GM SERVICE AND PARTS OPERATIONS  
DCS1360  
URGENT - DISTRIBUTE IMMEDIATELY

Date: March 9, 2005  
Subject: 05039 / Safety Recall  
Brake Pushrod Retaining Clip  
Models: 2005 Chevrolet Tahoe and Suburban  
2005 GMC Yukon and Yukon XL  
2005 GMC Denali and Denali XL  
To: All Chevrolet and GMC Dealers  
Attention: Service Manager, Parts Manager and  
Warranty Administrator

File In Section: Product Recalls  
 Bulletin No.: 05039  
 Date: March 2005

**SUBJECT: BRAKE PEDAL PUSHROD RETAINER**

**Non Adjustable Brake Pedal Pushrod Retaining Clip (4)**

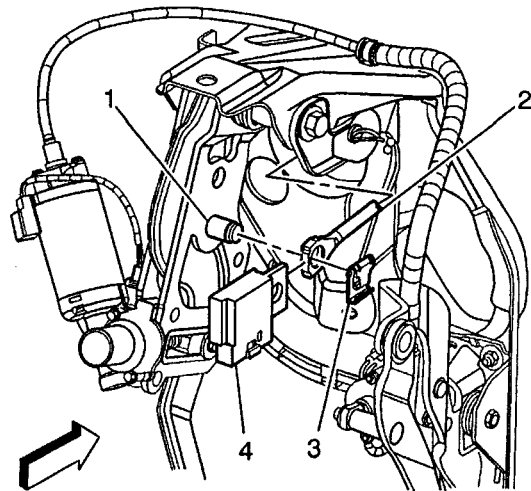
1. Inspect for the presence and proper installation of the brake pushrod retaining clip.

**Adjustable Brake Pedal Pushrod Retaining Clip (3)**

2. Install a new clip if necessary.
